SERVICE BULLETIN

C6, C7 and C9 SURFACEMAX™ SERIES

Affected Product: C6, C7, and C9 SurfaceMax™ Series Lightheads

Installation Addendum

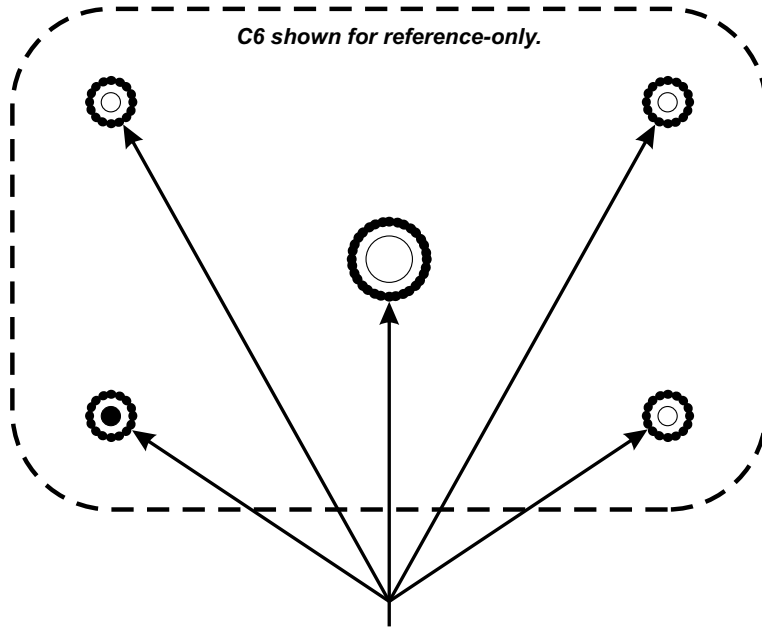
Installation Note:
A 1/8" thick bead of RTV silicone must be applied to the mounting surface so that it surrounds the wire passage hole(s) and the four mounting holes, forming a seal between the mounting frame and mounting surface.
